**GUJARAT NRE NO.1 COLLIERY MAJOR
EXPANSION PROJECT PART 3A
APPLICATION**

Preferred Project Groundwater Assessment

20 December 2013

GEOTLCOV24840AB-AB

Figure 1. Comparison of previous and current mine plans for Wonga East. Current mine plan sourced from Gujarat (2013) and overlaid with georeferenced information from Coffey (2013). Comparison of Panel Layouts for Wonga East.

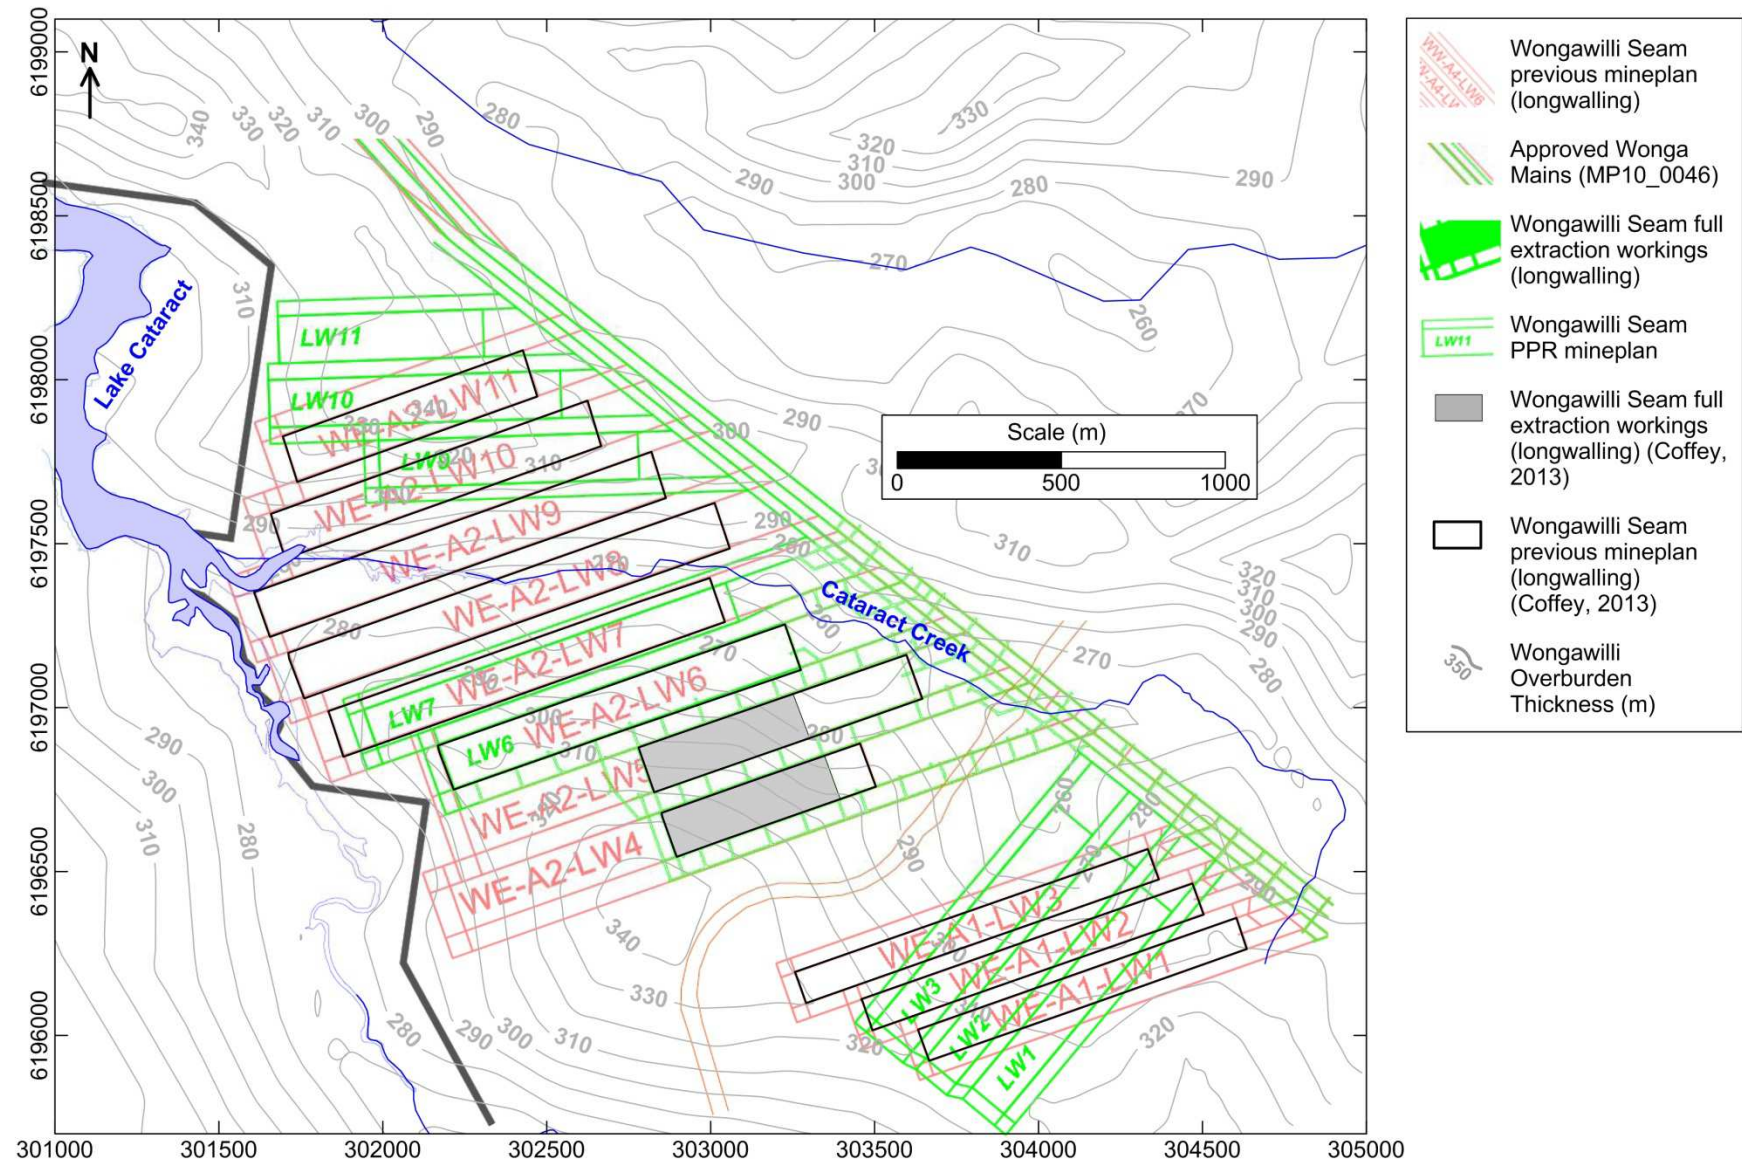
The new mine plan is presented in Figure 4 of the PPR however no scale is shown and it is not georeferenced. This mine plan was positioned with respect to the MGA by overlaying the EA and PPR mine plans of Figure 4 of the PPR onto a georeferenced drawing of the EA mine plan, and scaling it until a visual match was obtained between the two versions of the EA mine plan. The result is shown in Figure 1. This process allowed positioning of Cataract Creek (not shown in Figure 4 of the PPR) with respect to LW7 of the PPR mine plan. However, the positioning error from this process is unknown.

Based on the new mine plane, the PPR states that there is an interpreted risk of significant secondary impact to swamps BCUS4 and CCUS4.

Figure 2. Subsidence monitoring results for the (a) Balgownie and (b) Wongawilli panels at Wonga East (after Figures 49 and 58 of the PPR).

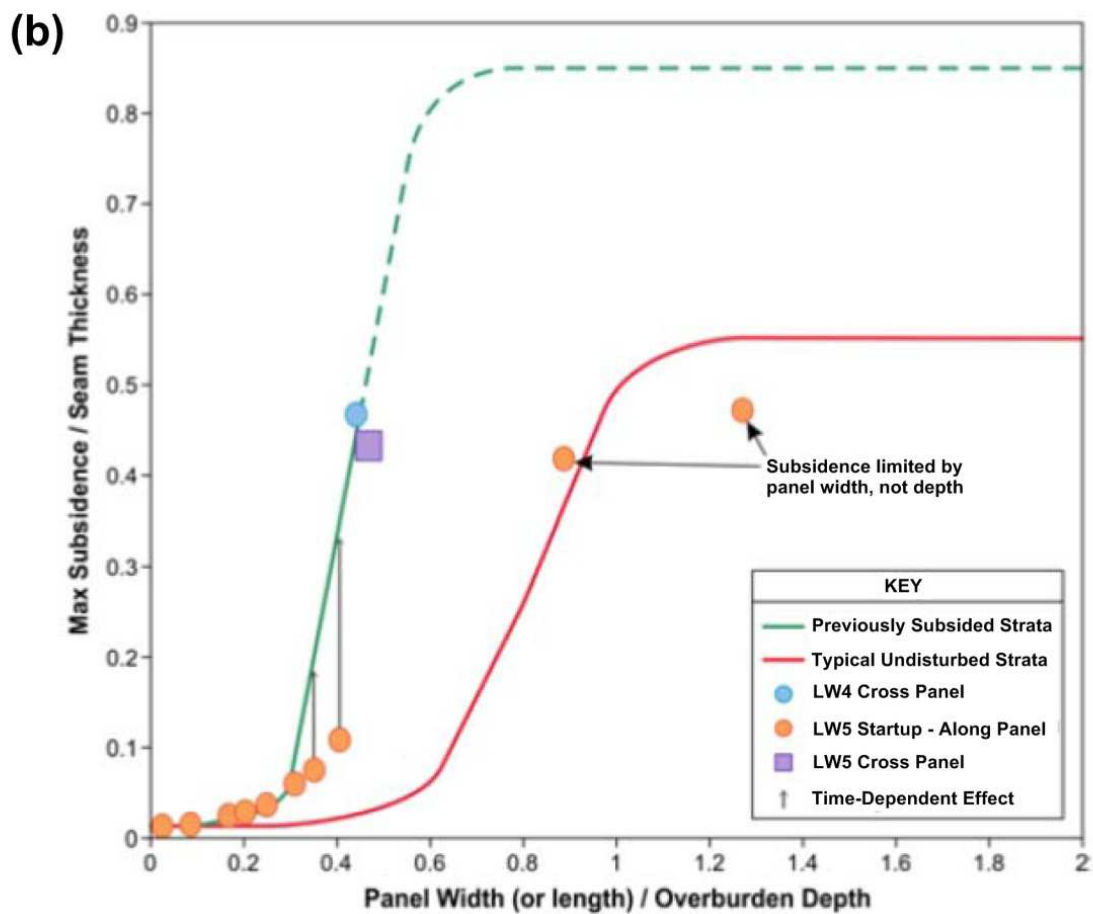
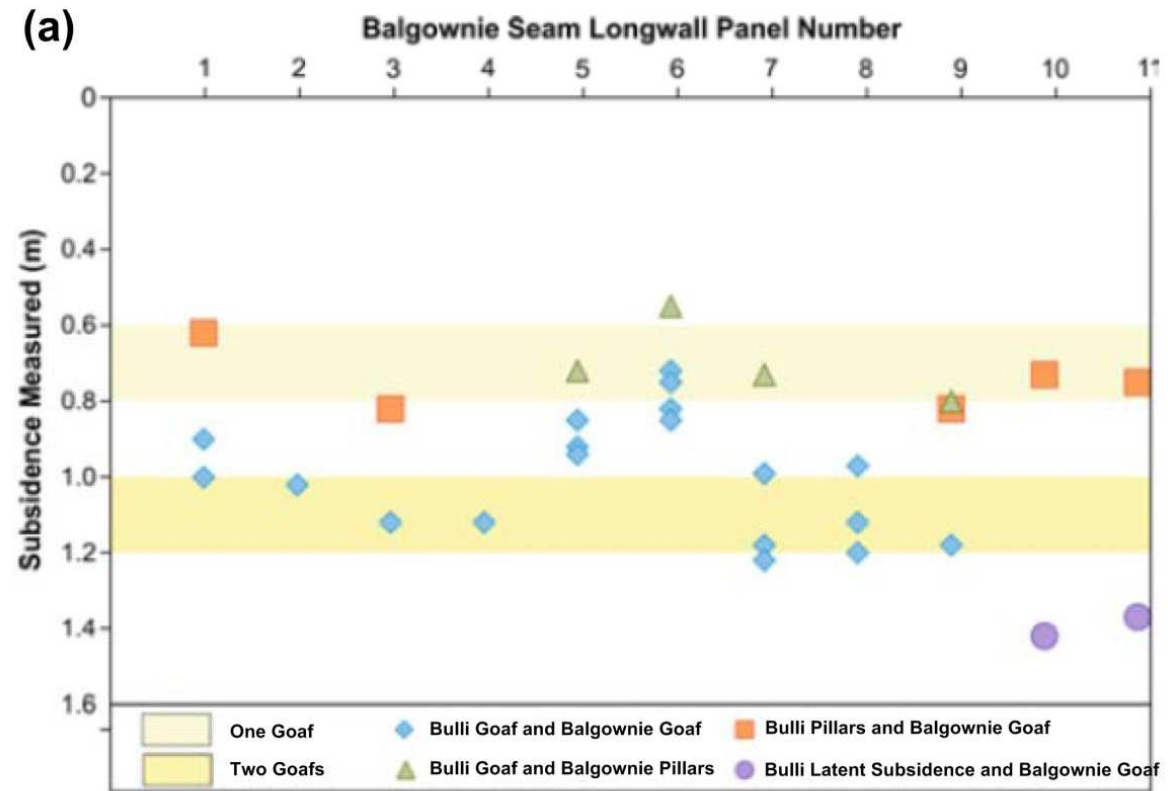
Subsidence measurements over existing total extraction workings in the Wongawilli East area are presented in detail in the PPR. These measurements are important as an indicator for the subsidence behaviour in a multiple seam mining environment. Subsidence monitoring of Balgownie and Wongawilli Seam panels in Wonga East indicates that incremental Balgownie panel subsidence ranged between 0.9m and 1.2m where overlying Bulli goaf (room and pillar panels with pillar extraction) was present, approaching 80% of the mined height (implying a mined height of about 1.5m for the Balgownie panels). In unusual areas (latent subsidence, goaf edge), the incremental subsidence reached 1.4m, approaching 100% of the mined height. Figure 2a (after Figure 49 of the PPR) shows these results.

Maximum incremental subsidence at Wongawilli LW4 was 1.4m. For the mining geometry of LW4, and assuming single seam mining, surface subsidence would be expected to range between 0.1m and 0.3m, about 14% of the observed subsidence where Balgownie and Bulli goafs are present. The PPR states that cross panel subsidence profiles indicate that the maximum subsidence in the centre of the Wongawilli panels is controlled by overburden bridging capacity rather than strata recompression. The presence of overlying goafs reduces the bridging capacity of overlying strata, having a significant effect on maximum incremental subsidence for the Wongawilli panels. It was also observed that the additional subsidence was confined to the panel footprint. Figure 2b (after Figure 58 of the PPR) shows these results.

Surface subsidence results presented in the PPR indicate that the accrued surface subsidence from multiple seam operations is more than an addition of estimated single seam subsidences. Although a relationship between surface subsidence and the height of desaturation (H) is unavailable (due to the significantly greater dependence of surface subsidence on overburden depth compared to H), the surface subsidence results would suggest that the accrued height of the collapsed zone for multiple seam operations also may be more than an addition of estimated single-seam H values (Tammetta, 2012). If this is the case, the consequence is that, where a Wongawilli panel underlies existing full extraction workings, the height of H for the Wongawilli panel will be larger than that calculated using the relationship for single seam mining (Tammetta, 2012).

Figure 4. New proposed position of Wongawilli LW7 as per the PPR.

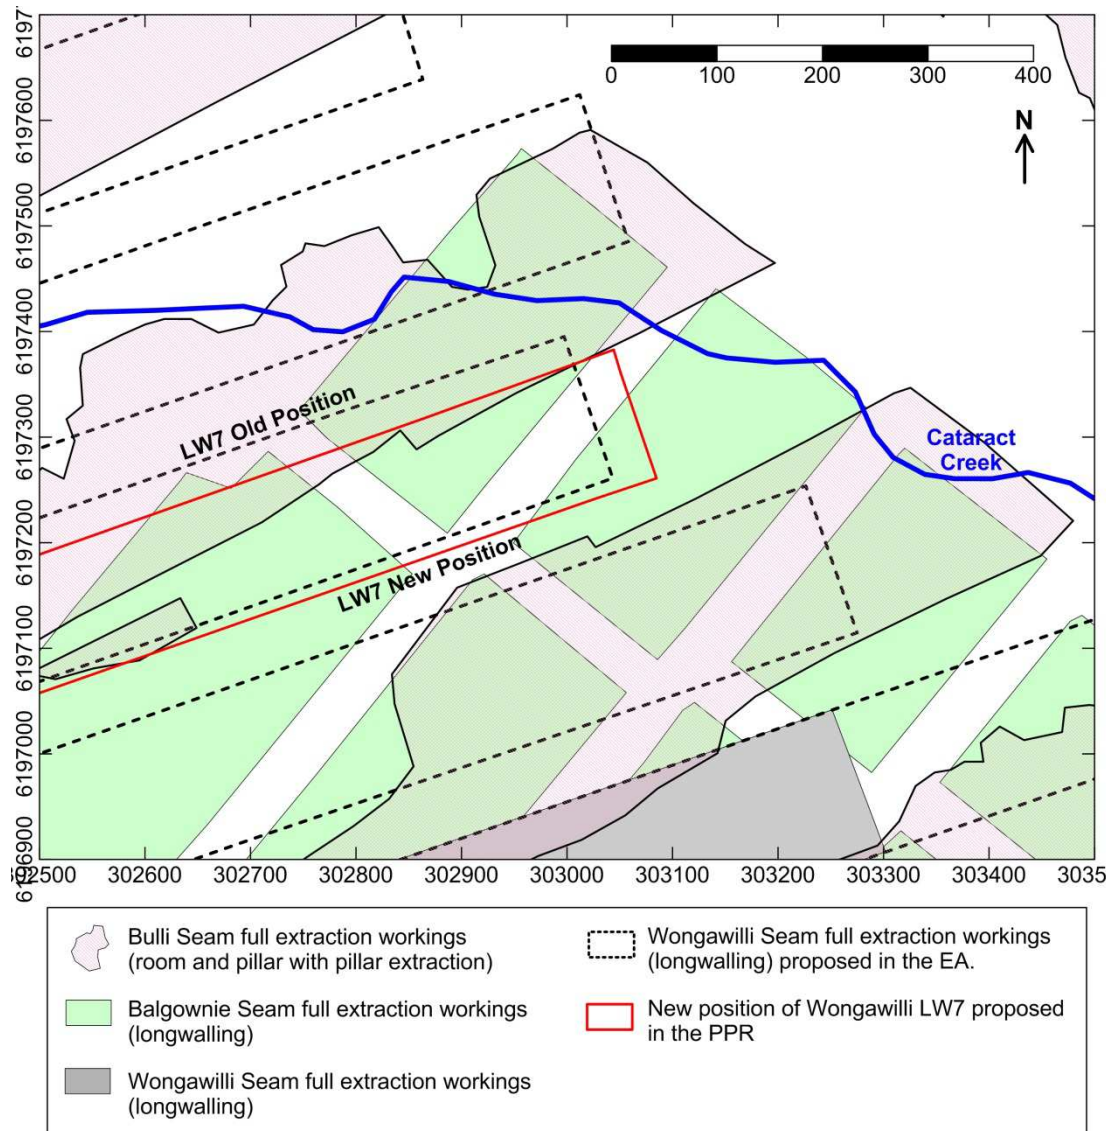
The new layout of LW7 is shown in detail in Figure 4. Subject to the accuracy of the positioning of the panels (the positioning of the new mine plan is approximate (see above) and the channel centreline was digitised from information in Geoterra 2012a, 2012b, and ERM, 2013, see also Coffey, 2013), it appears that the last 40m of the new LW7 position ceases to be overlain by any part of the adjacent Bulli room and pillar panel. The localised northern corner of LW7 is now positioned under a small, about 50m wide, devoid of existing full extraction workings.

While the method of Tammetta (2012) is useful for estimating H for a single seam operation, and was useful in identifying areas of concern for the EA longwall layout, it cannot be used over such a small area of observation for multiple seam mining.

The minimum separation distance between the northern corner of LW7 and the Cataract Creek channel centreline is approximately 45m (see Figure 4). Despite the absence of existing full extraction workings over a small strip of about 50m width, there may still be a risk to the capacity of the channel of Cataract Creek to transmit surface water. There may also still be a risk of direct hydraulic connection between the creek channel and goaf, through the collapsed zone, where the channel comes to close to the panel edge. The significance of these risks cannot be quantified, but warrants consideration.

Since the potential risk to Cataract Creek revolves around H for LW7, it is recommended that the height of the collapsed zone be measured at LW4 or LW5, at a location where all three coal seams have been mined. At least one borehole should be installed for this purpose, however two would be preferable. Since this survey would benefit all parties, and the cost is not small, perhaps some of the cost can be born by government. Should this be possible, the government should retain rights to the data.

Appropriate monitoring of groundwater response and ground deformation should be undertaken for LW7, from LW7 startup or earlier, whereby sufficient warning is available to allow termination of LW7 before connection of the creek channel to the goaf occurs. Deferral is made to ground movement experts on the appropriate type of ground movement monitoring and instrumentation (and its location) to fulfil this purpose.

Figure 5. VWP hydrographs for Monitoring Location GW1 (see Coffey, 2013).

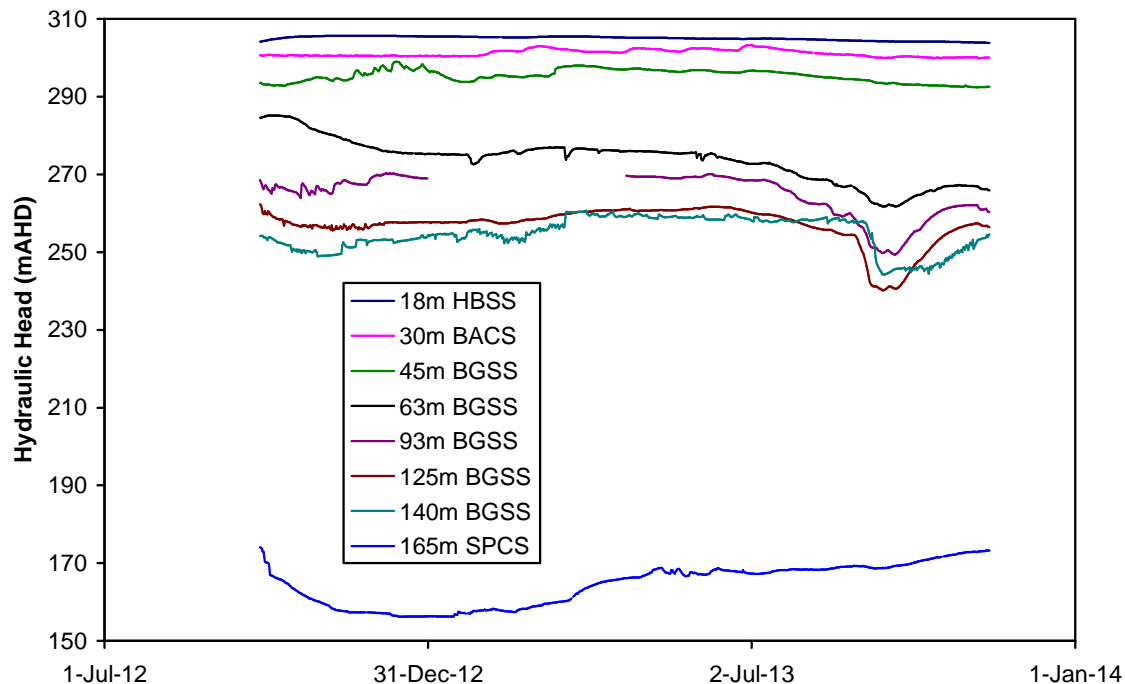
Hydraulic head monitoring data from the vibrating wire piezometer (VWP) nest at GW1 (see Coffey, 2013) were selected by the proponent for collection of near-field drawdown from longwall advance, for the purpose of model calibration. The monitoring data were not presented in the PPR but were supplied by Gujarat by email on 19 November 2013, at the request of the reviewer. Figure 5 shows the supplied data. The key in Figure 5 shows the depth below ground for each VWP, and the lithology at that depth (HBSS, BACS, BGSS, and SPCS denote the Hawkesbury Sandstone, Bald Hill Claystone, Bulgo Sandstone, and Stanwell Park Claystone respectively). The hydrographs for Bulgo Sandstone VWPs capture the effect of depressurisation from LW5 in late 2012. The measured drawdown is considered useful for model calibration of near-field disturbance.
